Value Engineering Report  
Design Development Stage

**STP-9252(6) and STP-9250(1)  
JOHNSON FERRY AND ABERNATHY ROADS  
WIDENING FROM THE  
CHATTAHOOCHEE RIVER TO ROSWELL ROAD  
P. I. Nos. 751300 and 715310  
Cobb and Fulton Counties, Georgia**

December 2006

**Georgia Department of Transportation  
District 7**

DESCRIPTION: **DELETE ONE NORTHBOUND LANE FROM JOHNSON FERRY ROAD BRIDGE**

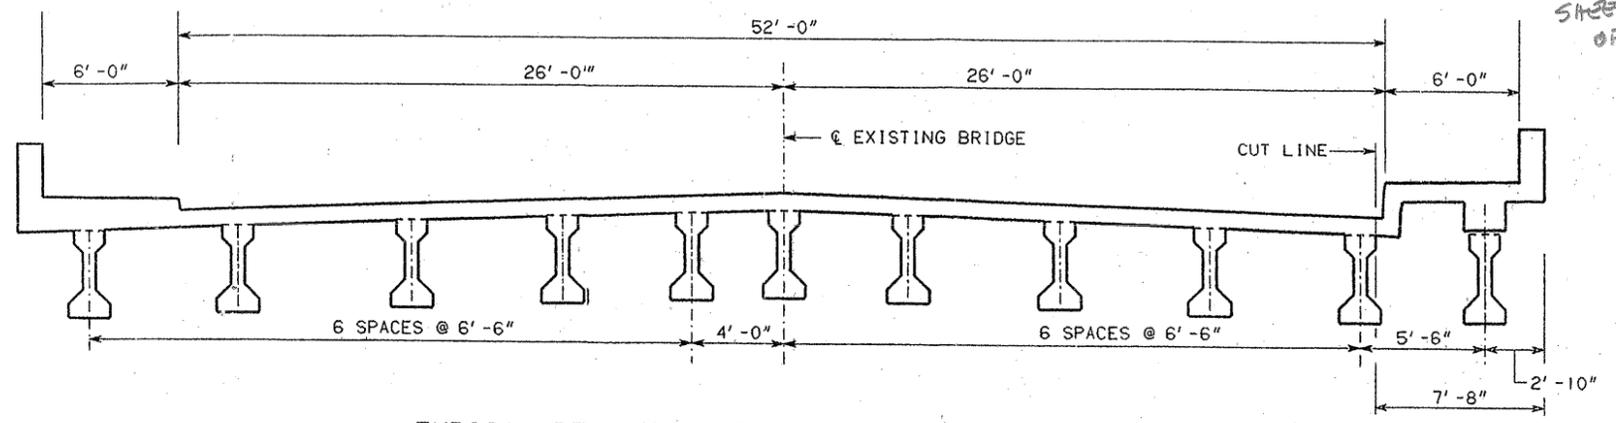
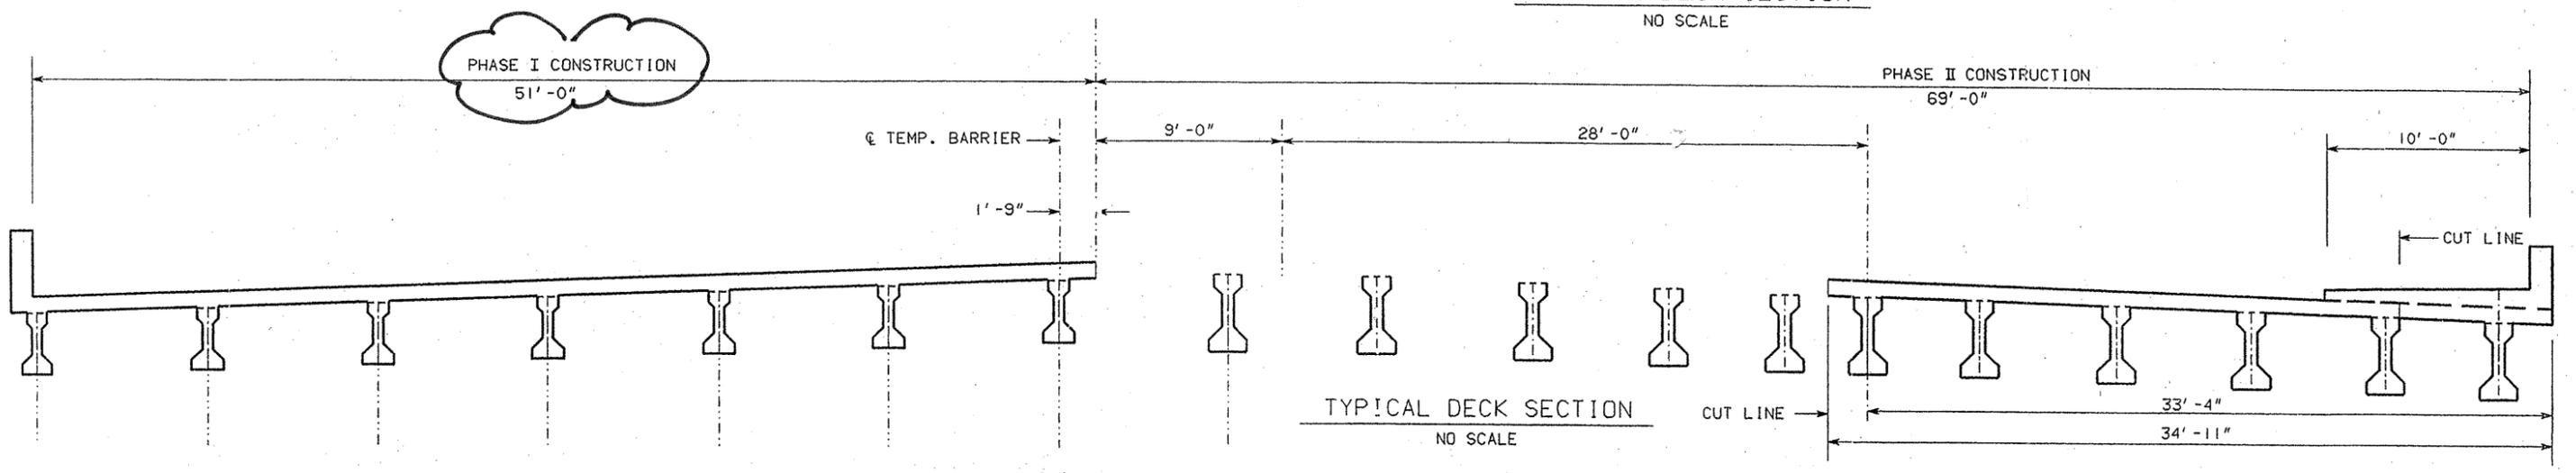
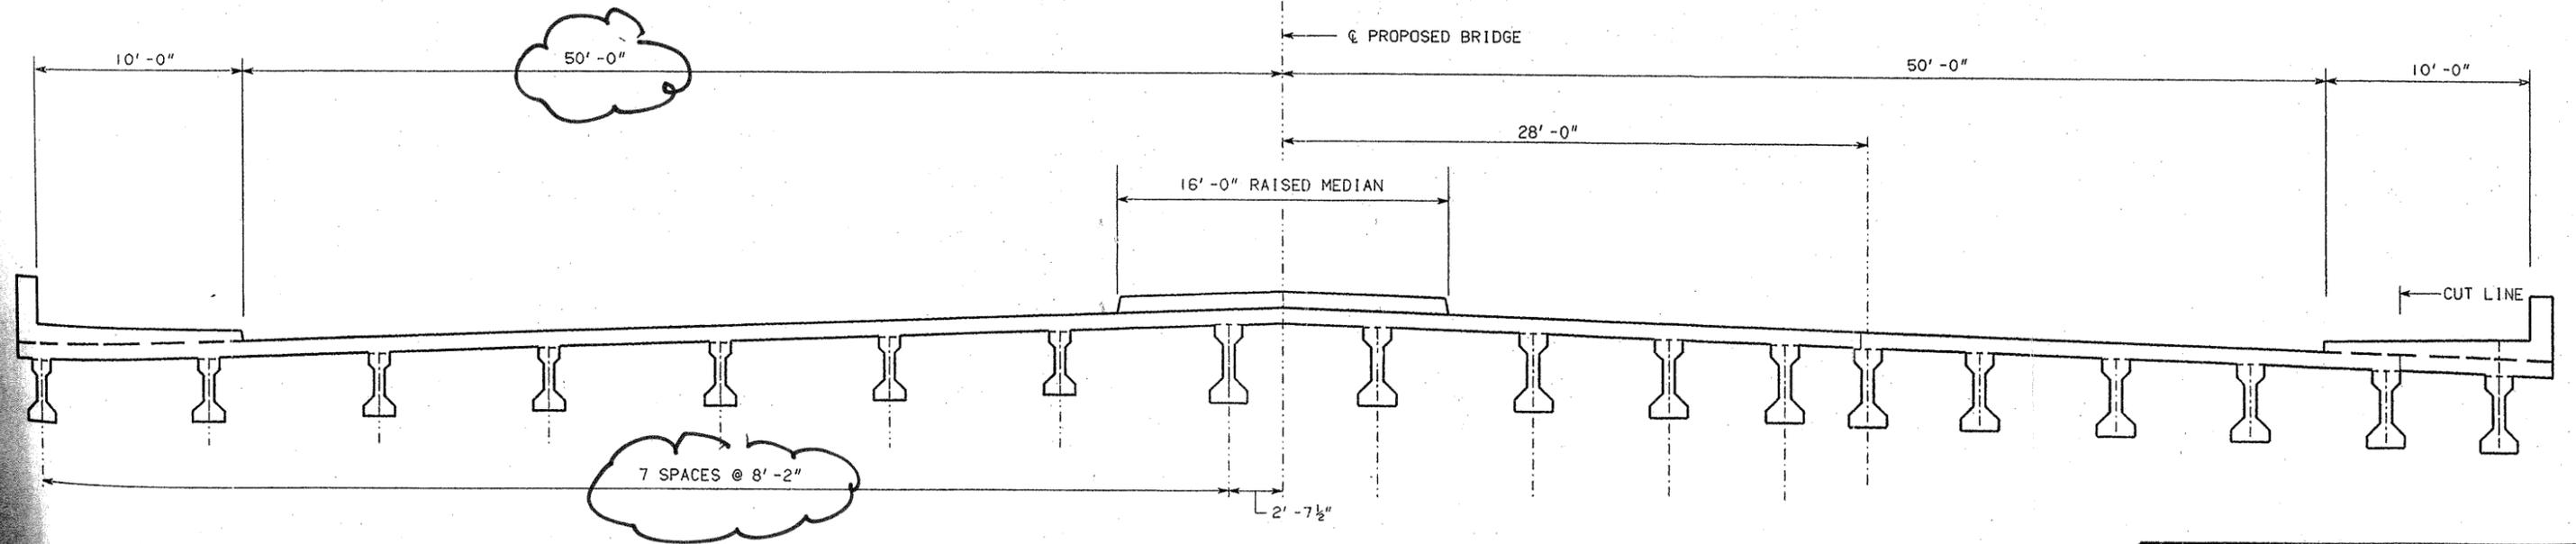
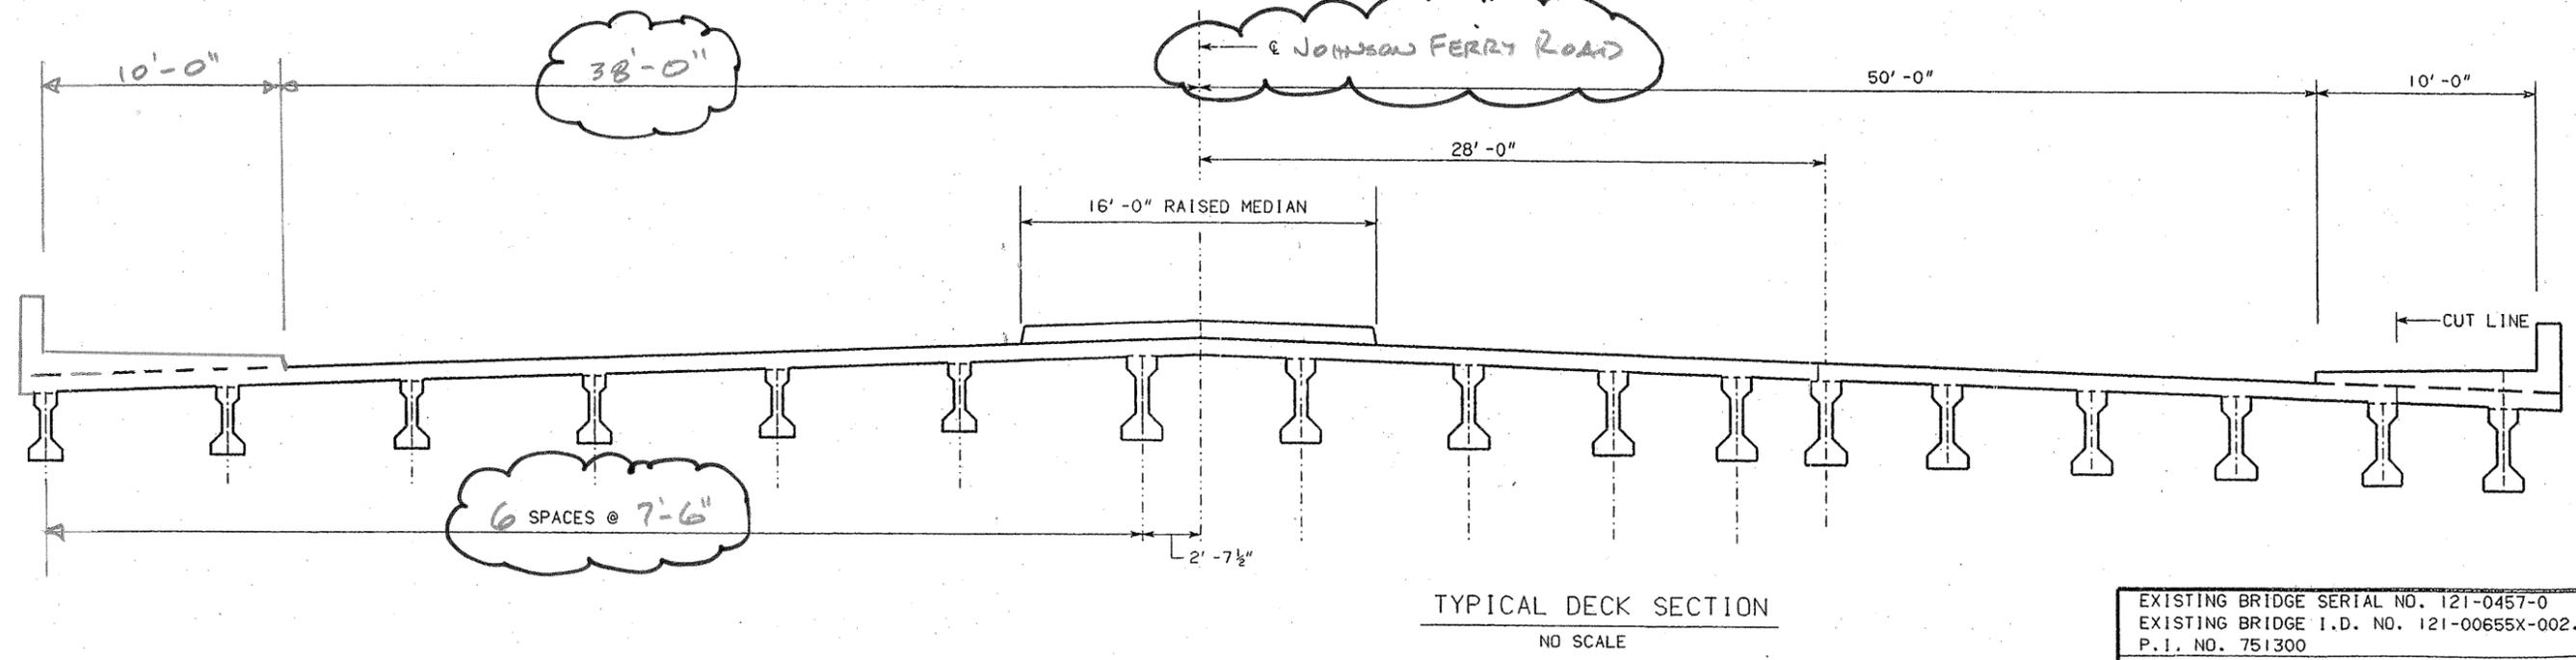
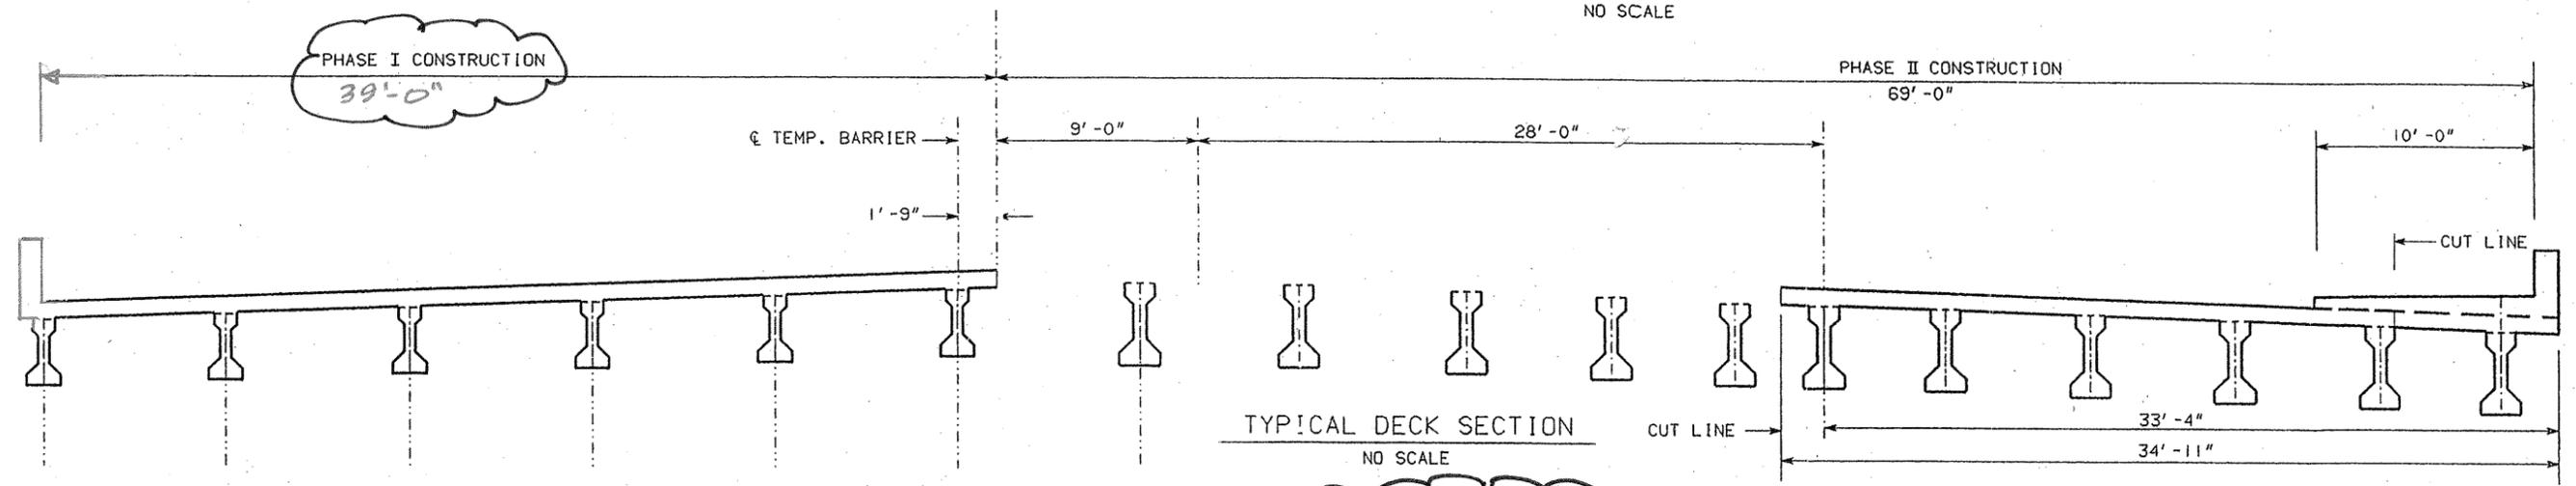
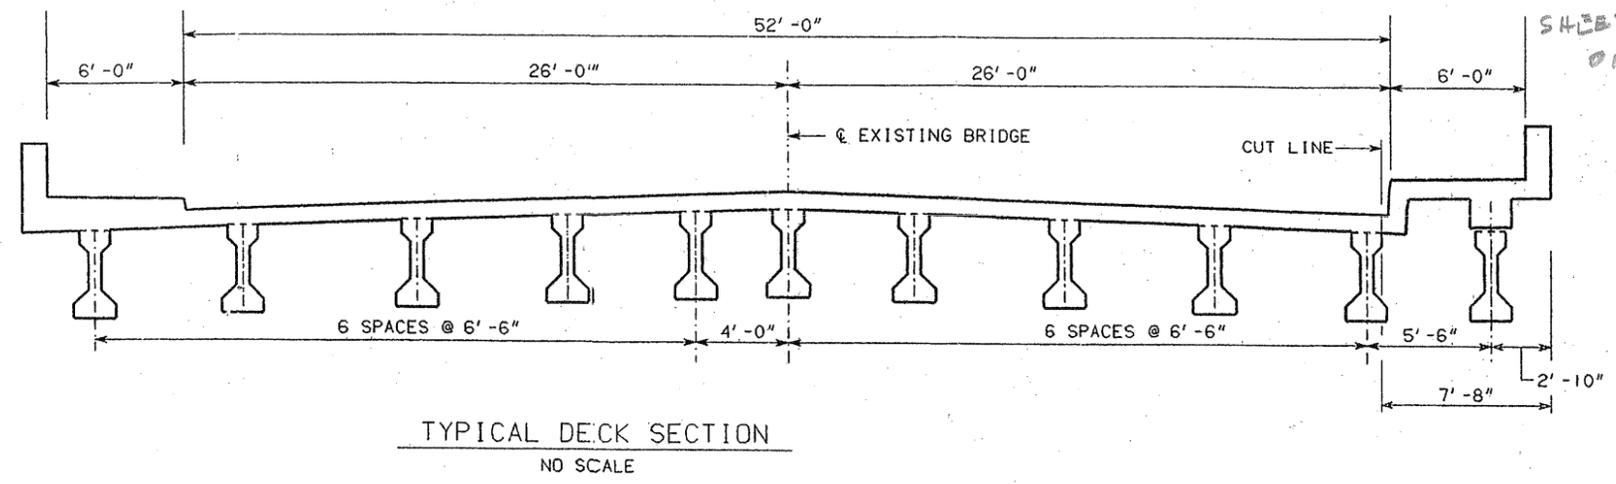
On the Johnson Ferry Road bridge, provide only two northbound through lanes to match the roadway section south of Riverside Drive.

- Requires stop or yield for traffic on Riverside Drive turning right to go north on Johnson Ferry Road
- Could create staging or traffic maintenance problems

At each intersection south of the Johnson Ferry Road bridge, there is a short acceleration lane. The same can be built at Riverside Drive and it would taper out before the Johnson Ferry Road bridge resulting in reduced deck area and one fewer line of beams. (See related Alternative No. 14.)

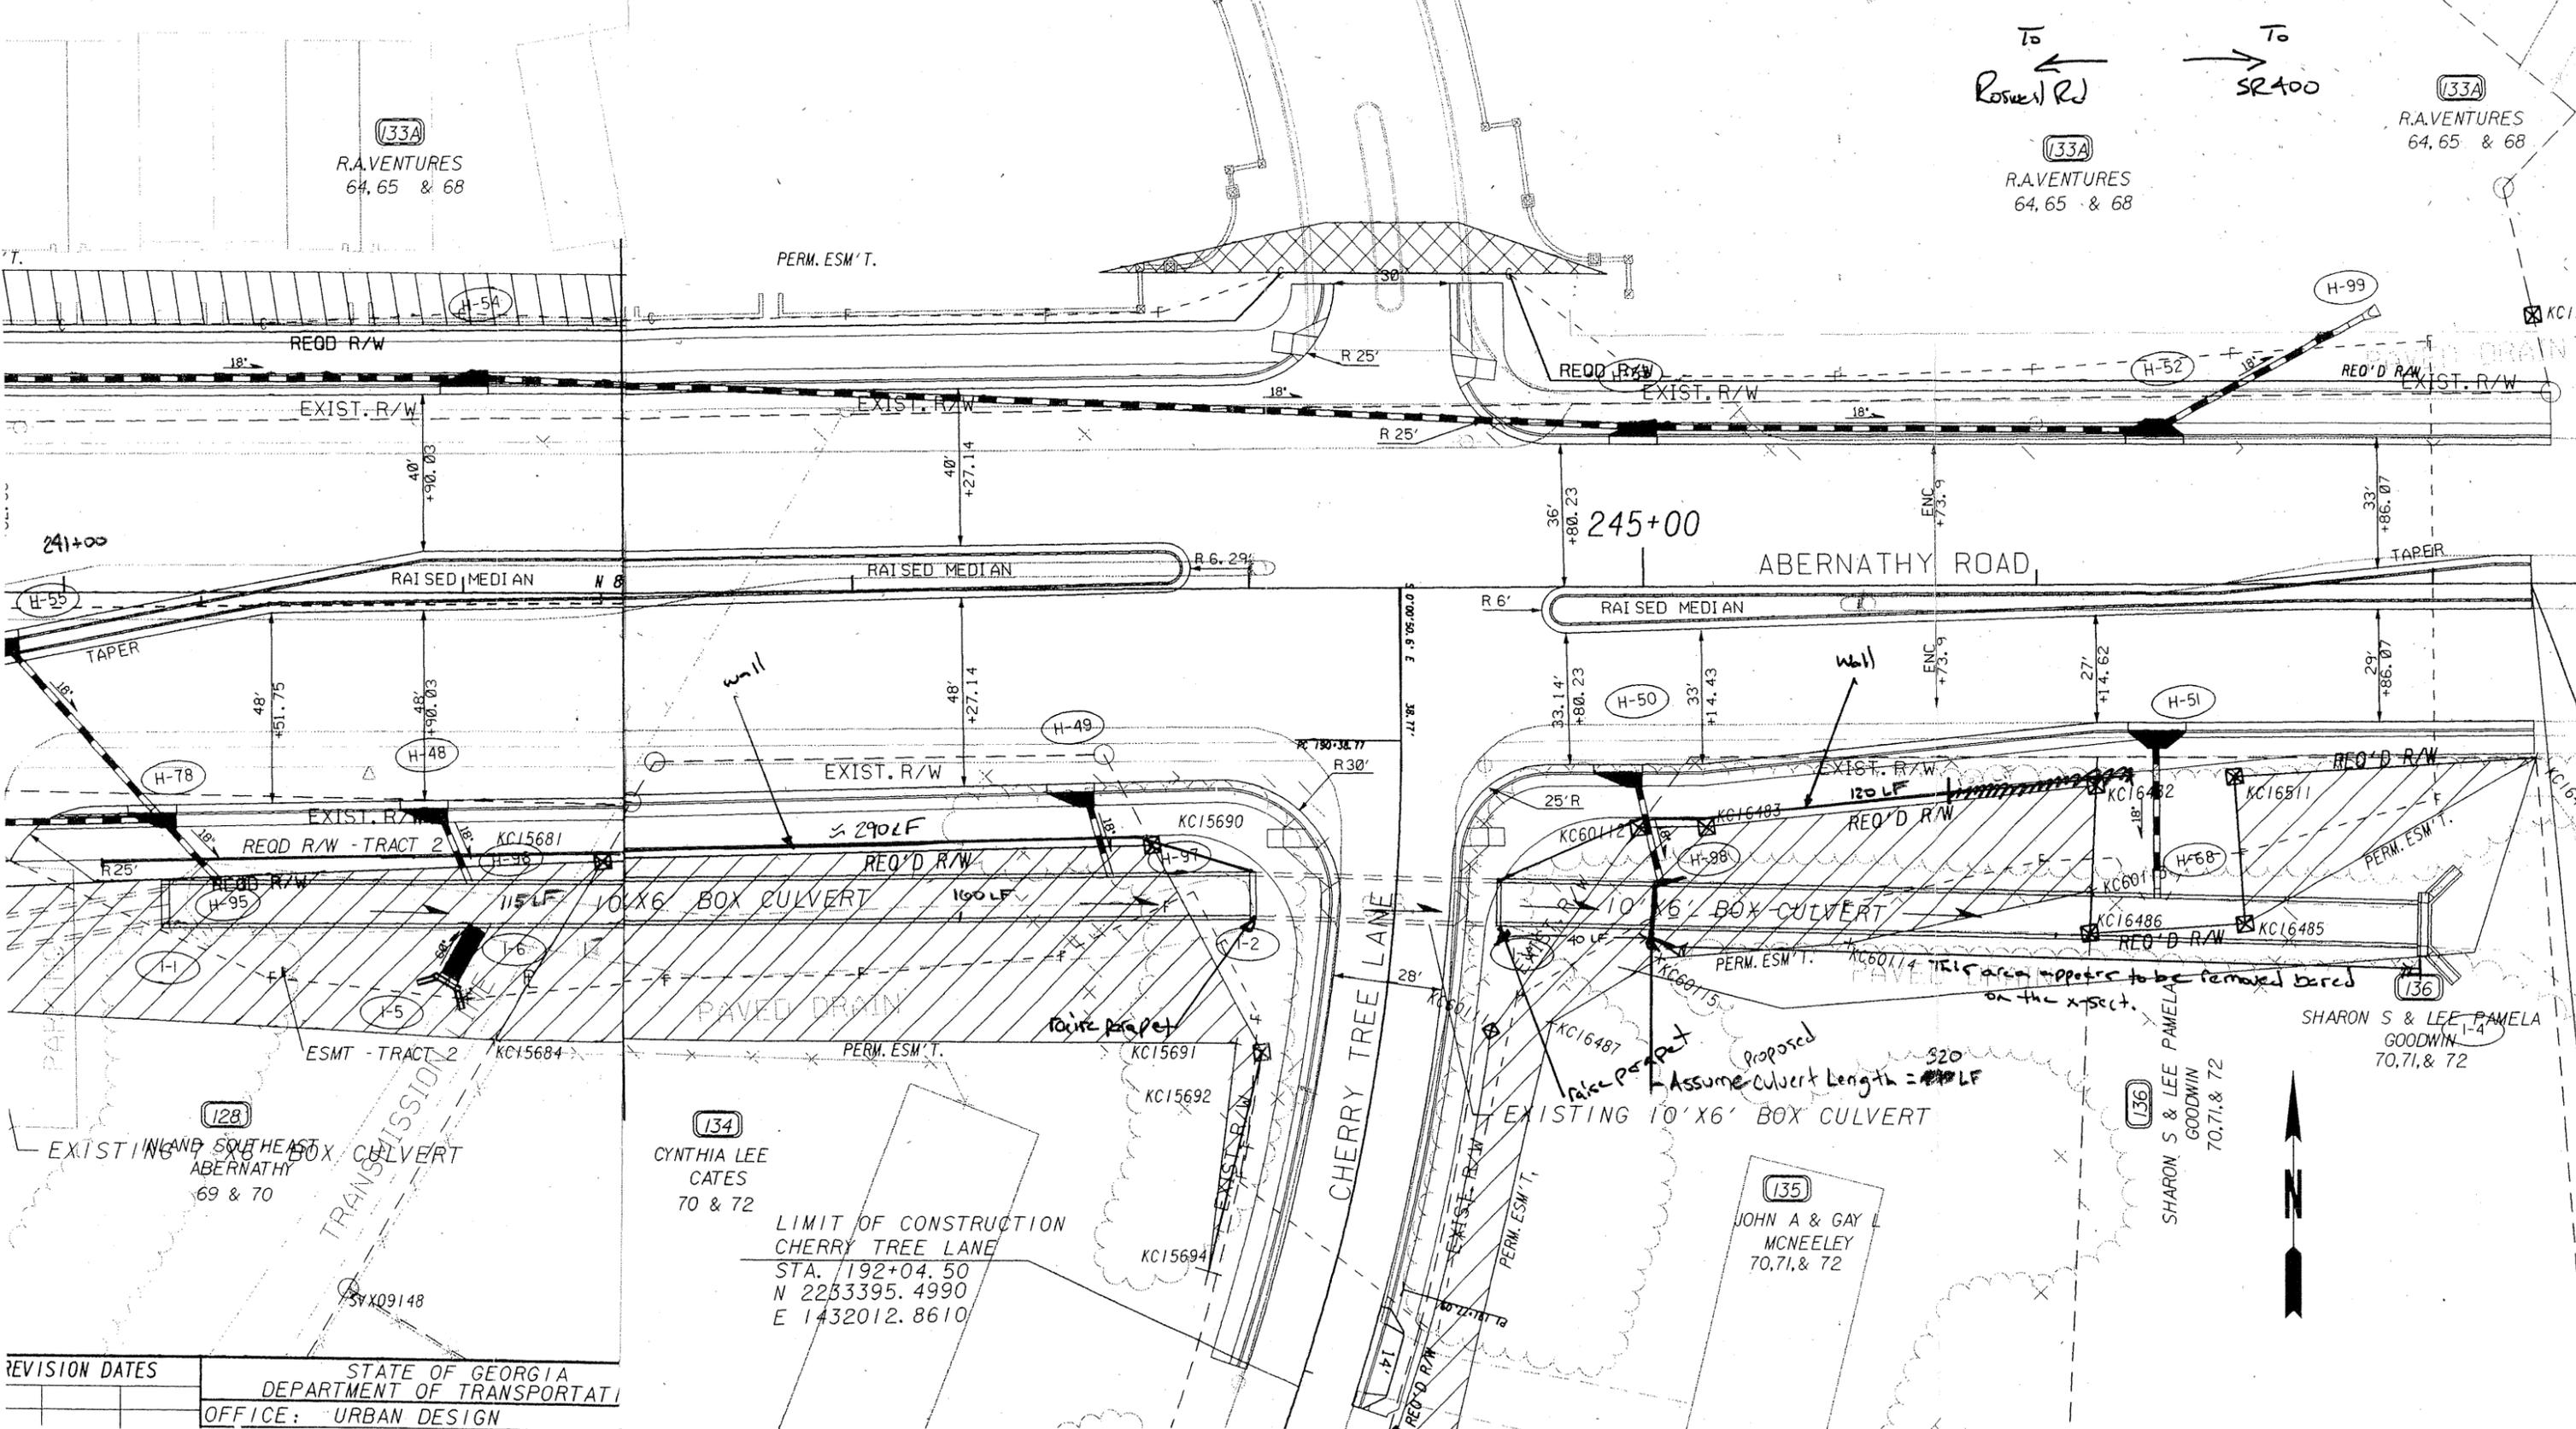
Using a retaining wall system would reduce the need for a permanent easement – the cost associated with this action has not been calculated.

It is noted that the cross sections and plans do not match in the provided documentation. The cross sections show the box culvert ending at STA 244+50 right and the plans show the culvert ending at STA 247+00. For the purposes of this alternative, it was assumed the cross section length was correct at 320 LF vs. the 510 LF indicated on the plans. This discrepancy needs to be corrected before project is bid.
